DUKE POWER COMPANY

OCONEE NUCLEAR STATION, UNIT 1

AMENDMENT TO FACILITY OPERATING LICENSE

ATTACHMENT TO LICENSE AMENDMENTS

UNIT 3
OCONEE NUCLEAR STATION
Figure 3.5.2-1C3

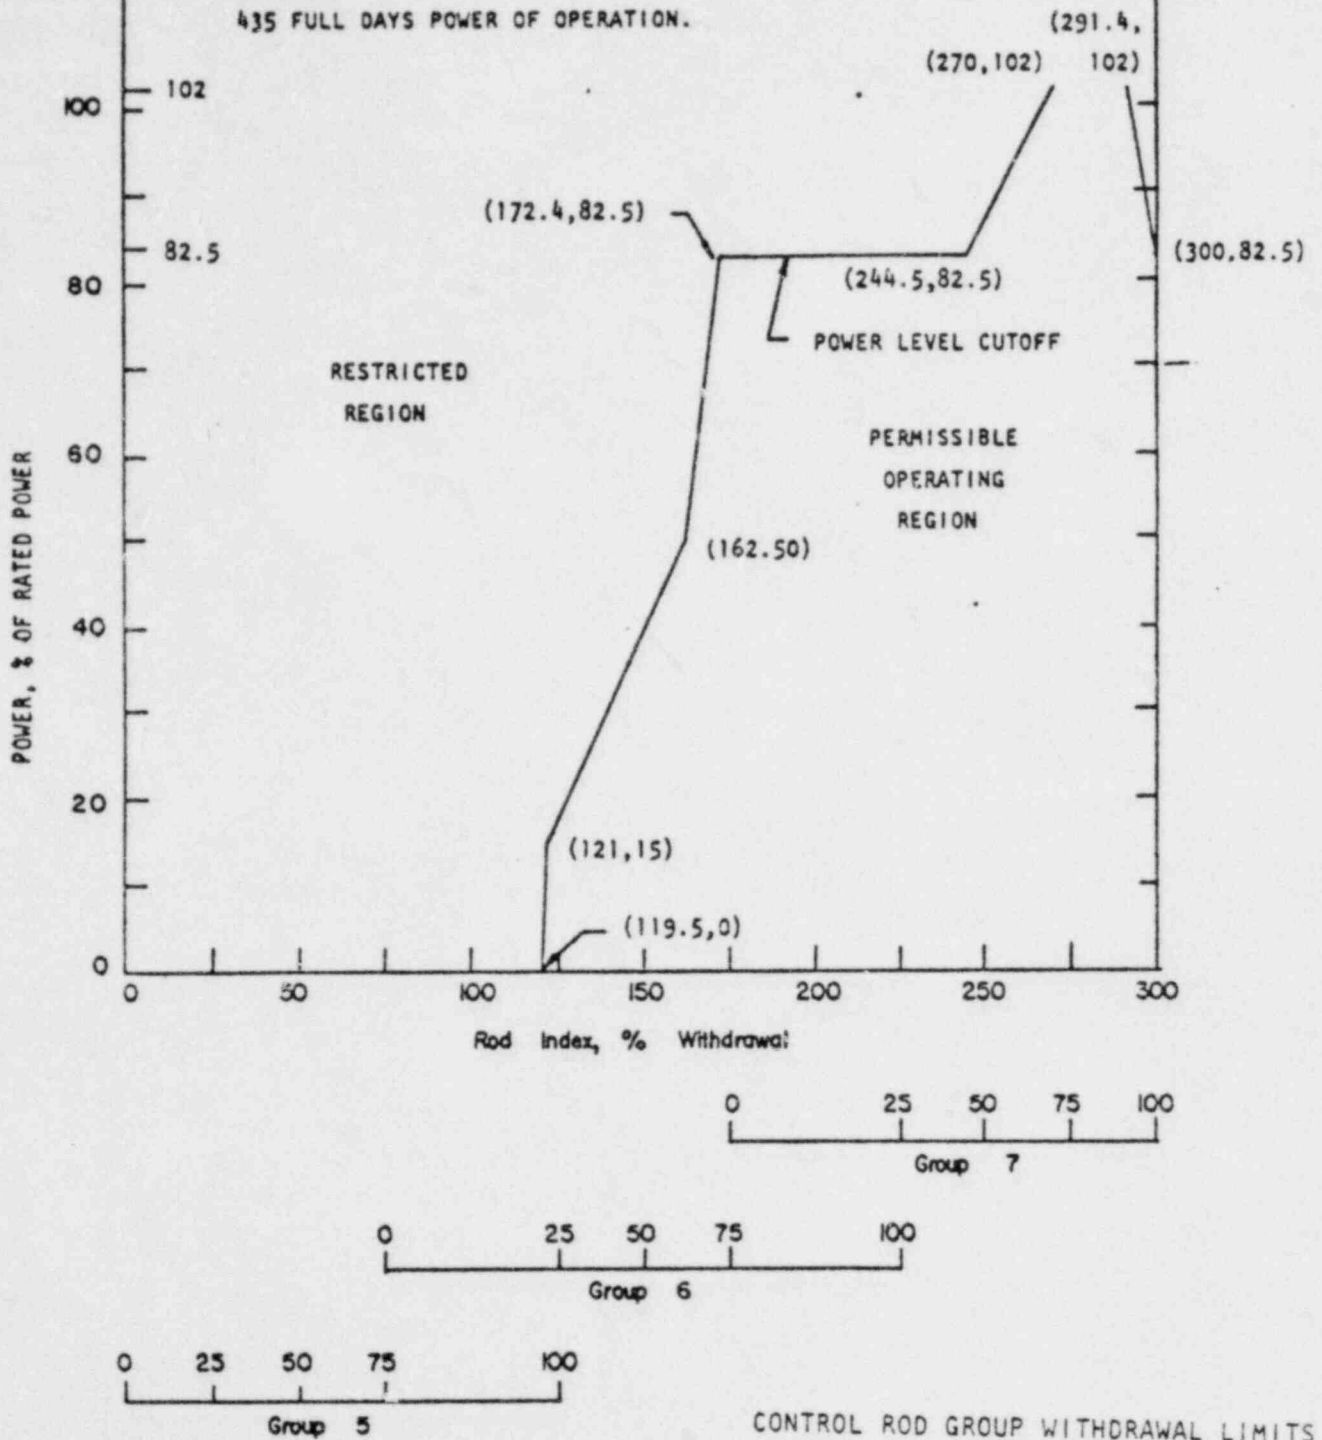
1. ROD INDEX IS THE PERCENTAGE SUM OF THE WITHDRAWAL OF THE OPERATING GROUPS.
2. THE ADDITIONAL RESTRICTIONS ON WITHDRAWAL ARE IN EFFECT AFTER 435 FULL DAYS POWER OF OPERATION.
